Department of Transportation

MEMORANDUM

SUBJECT: ZC Case No. 04-14H – 25 Potomac Avenue SE (Capitol Riverfront Phases 3 and 4)

Figure 1 | Site Plan

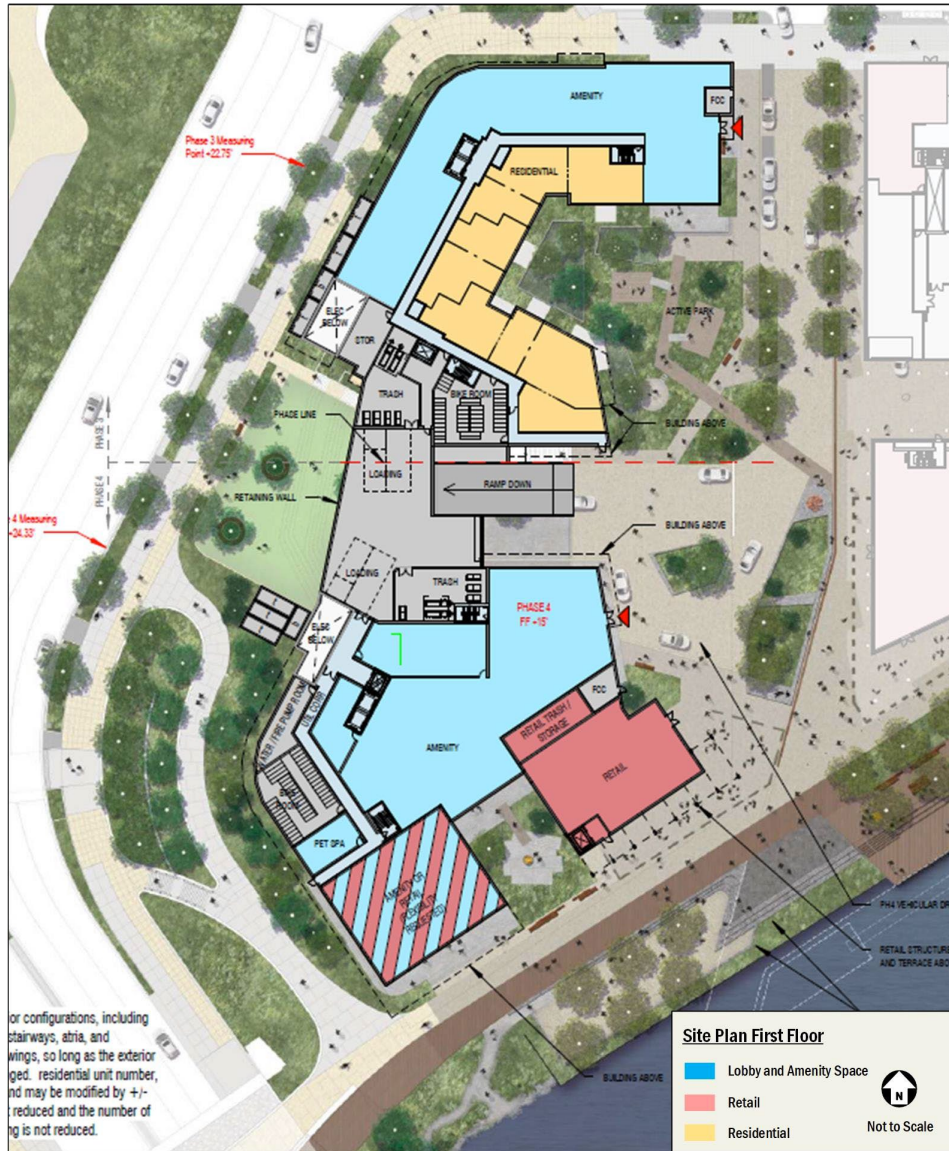
Pedestrian access is from internal walkways that connect to Potomac Avenue, South Capitol Street, and the Anacostia Riverwalk Trail. Residential lobbies are at the northeastern corners of each building, and pedestrian retail access is located on the southeast corner of the Phase Four building. Vehicular access to the shared parking garage and loading facilities is proposed from an internal driveway via an existing, two-way curb cut and driveway on Potomac Avenue built as part of previously completed PUD phases. The project proposes no new curb cuts to a public street, consistent with DDOT *Design and Engineering Manual (DEM)* standards for vehicle access. Figure 1 below shows the site layout of the proposed project.

Figure 5 | Existing Pedestrian Network

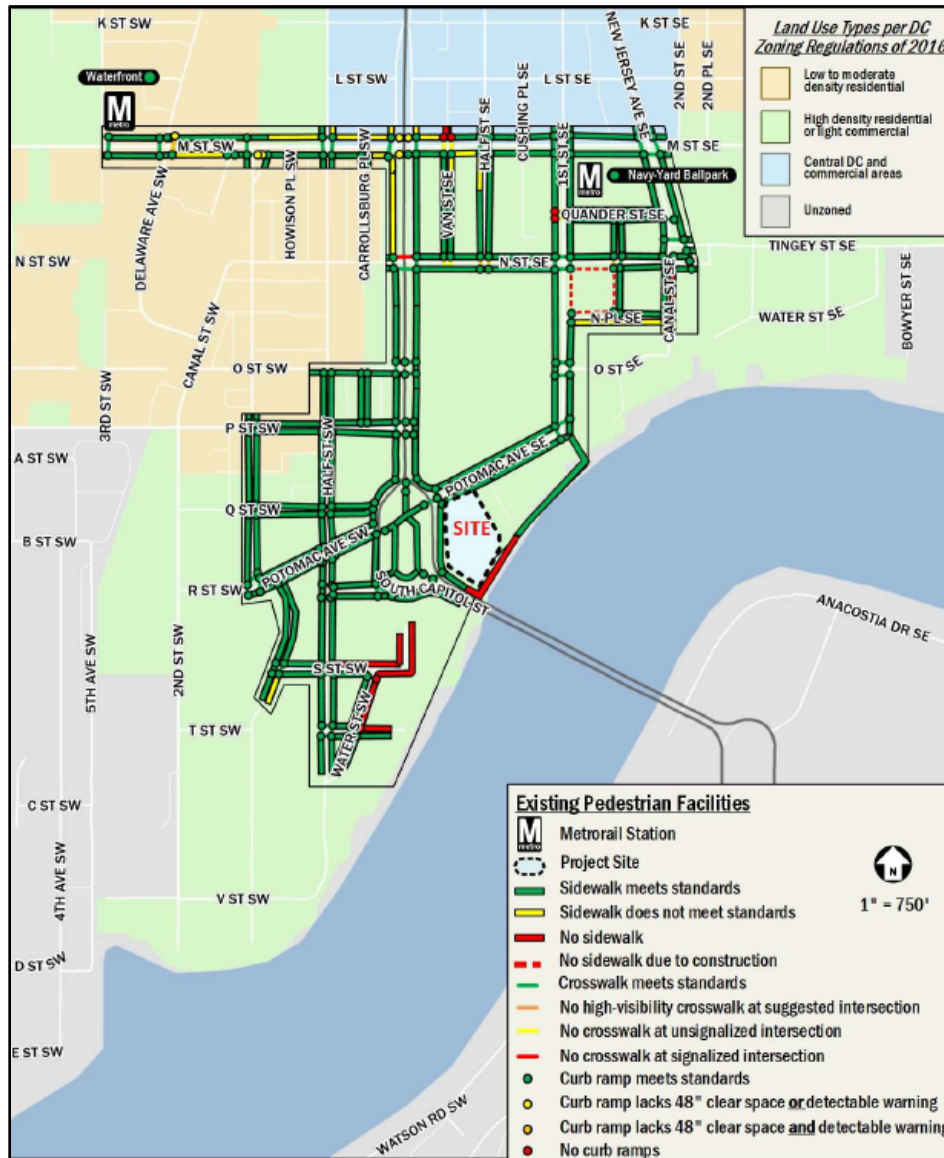
The CTR's inventory of existing pedestrian infrastructure, as shown in Figure 5 below, demonstrates that most sidewalks in the immediate vicinity of the site are currently constructed with appropriate widths and include accessible curb ramps. The Applicant will be extending the Anacostia Riverwalk Trail from the south side of the completed Phases 1 and 2 of the PUD site, along Phases 3 and 4, to the existing connection to the South Capitol Street oval. While there are a few missing or substandard facilities in the broader area, the existing pedestrian network along major walking routes from the site to schools, attractions, and the Metrorail station are generally adequate.
